**AESO 2007 Tariff Consultation:
Additional Stakeholder Comments
On July 21, 2006 Revised Tariff Proposals
September 20, 2006**

PPGA PROPOSED MODIFICATION OF THE AESO 2007 GTA RATE DESIGN, SEPTEMBER 12, 2006

Chart 1: Modifying the average cost function to represent the minimum cost function

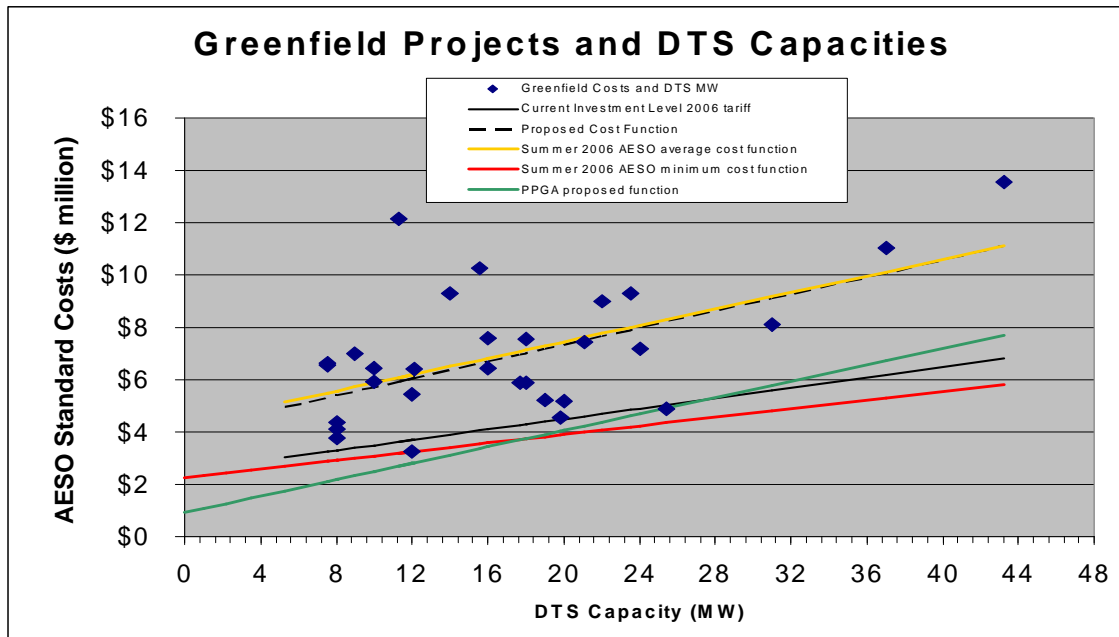
While the PPGA may support the AESO's *unique* methodology, the PPGA does not agree with one aspect of the methodology: adjusting the average cost function to a minimum cost function. The AESO scales both the y-intercept and the slope of the average cost function. (See Chart 1: The yellow line scaled to the red line). This method overstates the cost of smaller projects and understates the cost of larger projects. The PPGA does not feel it is appropriate to change the investment function slope since:

1. The slope is the “best fit” line for determining how costs increase as POD capacity grows.
2. The slope is the “best fit” for the “noise” of the transmission line lengths associated with the geographic location and other cost drivers associated with individual POD's. The transmission line cost is correlated to line length as demonstrated by the AESO's July/06 report. Retaining this slope for the investment function seems to be the only technique that will reflect the “best fit” variation in transmission line and other costs.

The minimum Y-intercept should be created by maintaining the slope of the average cost function and simply moving the curve downwards to a level that includes the two lowest cost Greenfield PODs (see Chart 1 green line). This method will create a minimum Y-intercept that maintains the integrity of the “best fit” regression line.

Applying PPGA's methodology to derive the minimum function from the average function results in a Y-intercept of \$0.919 million and maintains the average cost slope of \$0.157 million/MW, (see Chart 1 green line).

Chart 3: Derivation of the minimum function

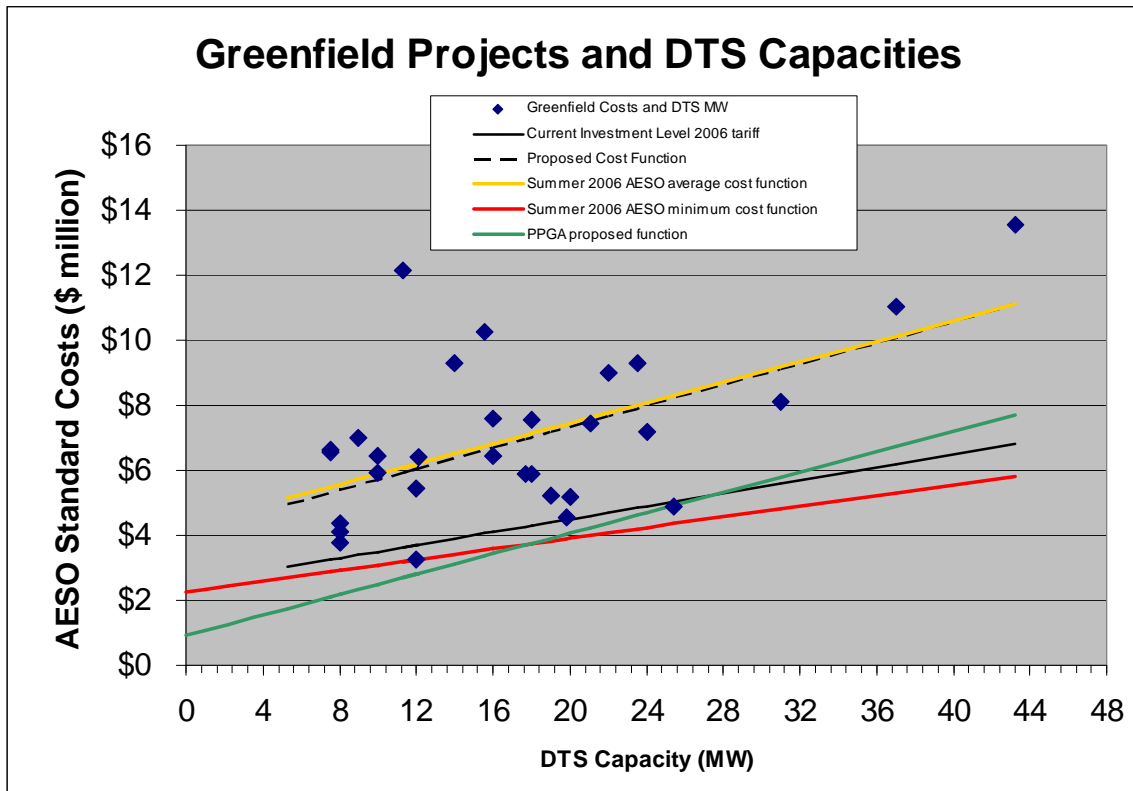
AESO 2006-07-21 proposal creates a minimum intercept by multiplying the investment y-intercept **and** slope by 0.4885. As discussed in the main body of this report, PPGA only scales the y-intercept retaining the slope of the cost function, resulting in a y-intercept of \$0.919 million and a slope of \$0.157 million/MW. The minimum intercept approach of the AESO and the PPGA are displayed in Chart 3 below.

The minimum cost function methodology does not affect large customers, as the slope of \$0.157 million/MW is retained for the larger customer base. Customers over 17 MW are subject to the average cost curve. Therefore, the minimum cost function is only important in the analysis to customers under 17 MW.

For customers between 7.5 and 17 MW, the chart above shows that the PPGA minimum capital costs for this load is \$2 to \$3.5 million. This appears to be a reasonable estimate of minimum POD costs.
